Appendix I1
Accessibility Audit Report

National Transport Authority
**Templeogue/Rathfarnham to City
Centre Core Bus Corridor Scheme**
Accessibility Audit Report

268401-00

Issue | 06 January 2022

Figure 18: Tactile Paving - Rathfarnham Road

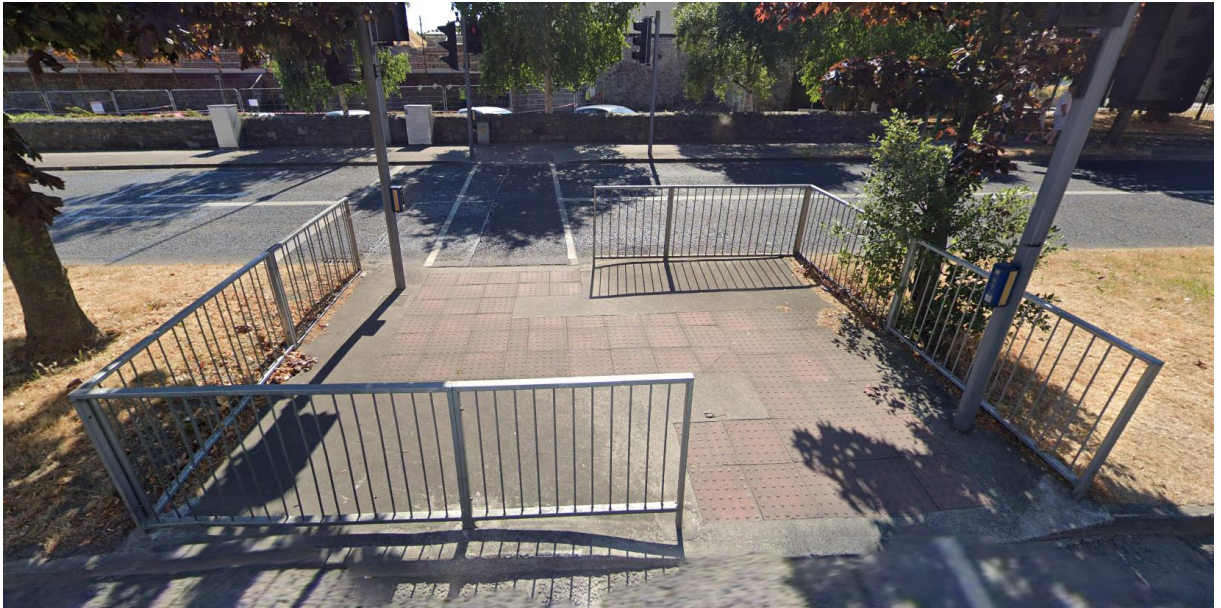
All controlled crossings feature tactile paving surfaces on both footpaths. The pedestrian island to the Rathfarnham Castle car park also features tactile paving as shown in Figure 18.

Figure 47: Surface Material – Rathmines Village

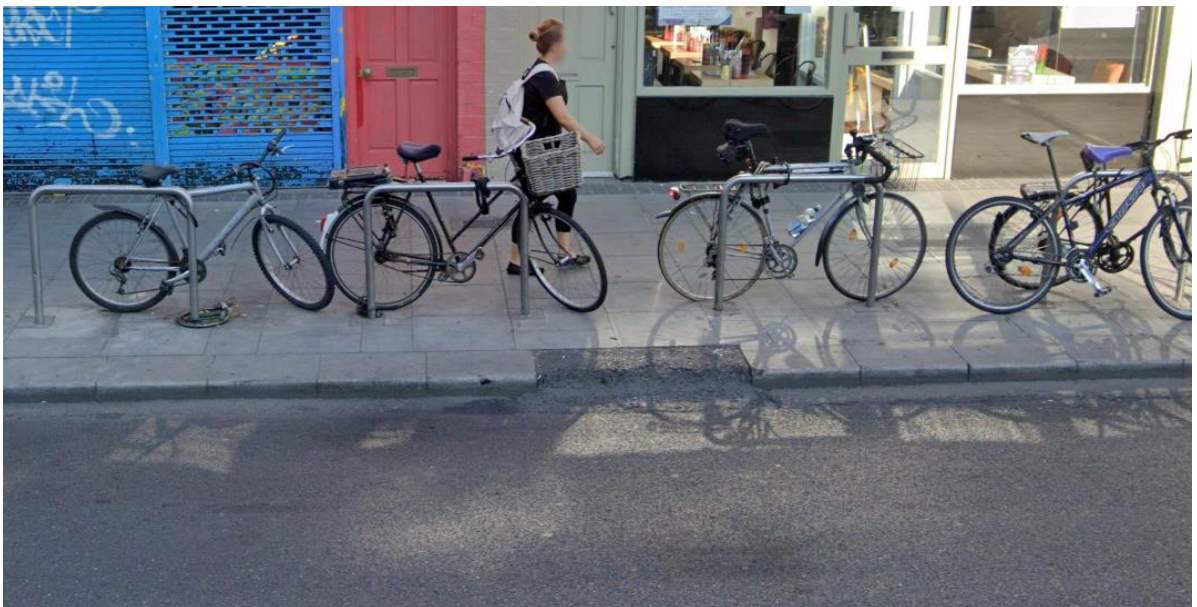
The surface material used for the footpath along this section of the route varies. The footpath through Rathmines is predominantly composed of granite tiles and kerbs as shown in Figure 47. Some in-situ concrete was observed, as well as minor asphalt patch repairs to kerbs.
